**CITY OF ST. HELENS PLANNING DEPARTMENT
STAFF REPORT
Conditional Use Permit CUP.1.26**

ZONING: Houlton Business District, HBD
LOCATION: 184 S. 15th Street
PROPOSAL: Complete building addition started c. 2014 but never completed, establish use as an artisan workshop or trade/skilled services with outdoor storage, and address unapproved site modifications.

TO: Planning Commission acting as the Historic Landmarks Commission
FROM: Jacob A. Graichen, AICP, City Planner
RE: 71 Cowlitz Street (The Klondike Tavern) Architectural Review
DATE: May 5, 2026

1 SITE PLAN
SP-1 1/8" = 1'-0"

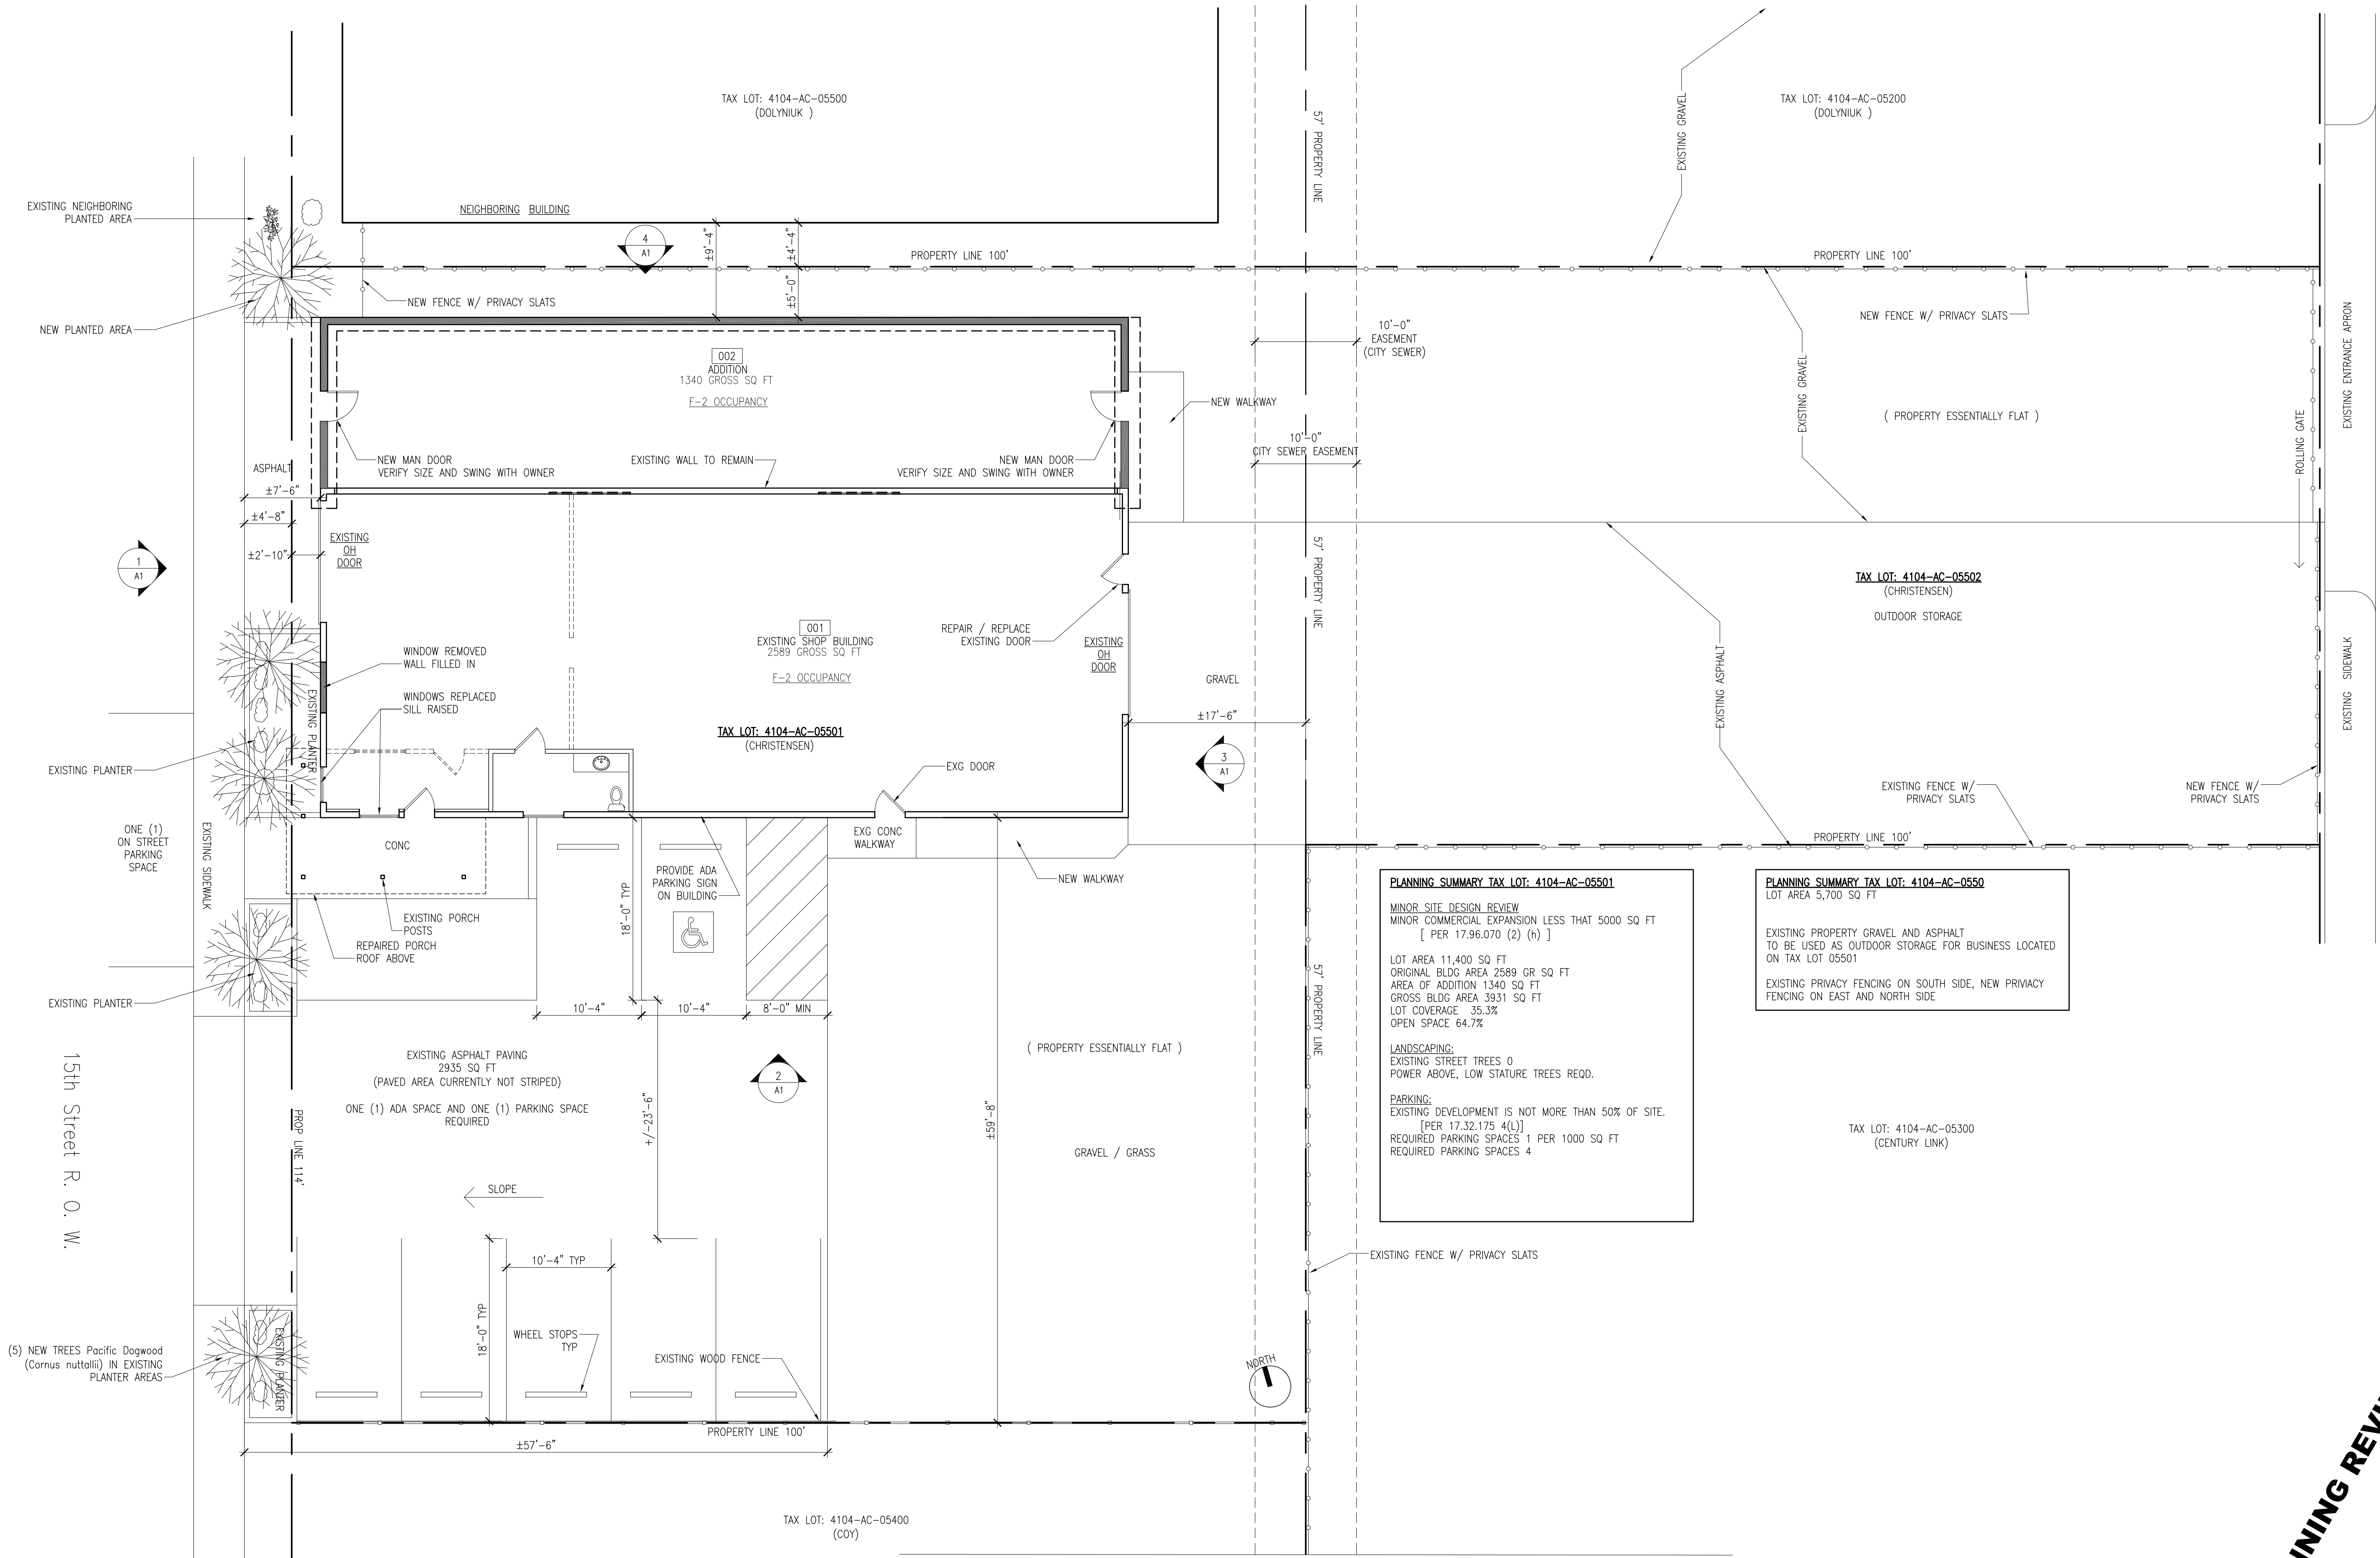
Dimensions. Standard parking spaces are 9' x 18'. For two-way vehicle circulation, 24' width is required. Thus, in order to have a row of standard parking spaces on either side of a 24' two-way aisle, the minimum width dedicated to vehicle use needed is 18+24+18 or 60 feet.

The site plan identifies 59'8". However, upon measurement by staff towards the middle of the paved parking lot area there is about 58 feet between the building and the fence along the south property line.

This raises accuracy concerns of the plans. As another example, measured on the plans, there is about 201' between the back edges of the sidewalks along S. 14th and S. 15th Streets. Measuring from aerial photos there is actually about 208'. It is also possible that the fence along the south property line is within the subject property, which may result in the claimed 59'8" dimension on the site plan (if measured to the property line), though, given the location of the fence, that is not the physically available area.

Moreover, a swath of area adjacent to the south side of the building has to be included as walkway that is either 4' wide or 7' wide (see access section below), which reduced this width further.

Plans revisions are needed for accuracy, better quality control and code compliance.

As noted above, plans show some walkway but not a connection to the street that avoid areas intended for vehicle use. Revised plans necessary. Minimum walkway width area is 4 feet and are required to be paved.

2. The following shall be required prior to commencement of any use:
 - a. Final plans shall include the following revisions:
 - i. Open space areas shall be specially identified and quantified. Open space cannot be areas used for other things such as storage, access, parking, etc.

- ii. All walkways, vehicle ways, and off-street parking shall be paved.
 - iii. Landscaping to achieve a balance of low-lying shrubbery and trees in addition to the proposed trees for the landscape areas along S. 15th Street. Methods of irrigation / plant maintenance for plant survival shall be identified.

- iv. Refuse container/collection area shall be addressed.
 - v. Plans shall be properly calibrated to existing (e.g., CS 5174 from 2004) or new surveys.
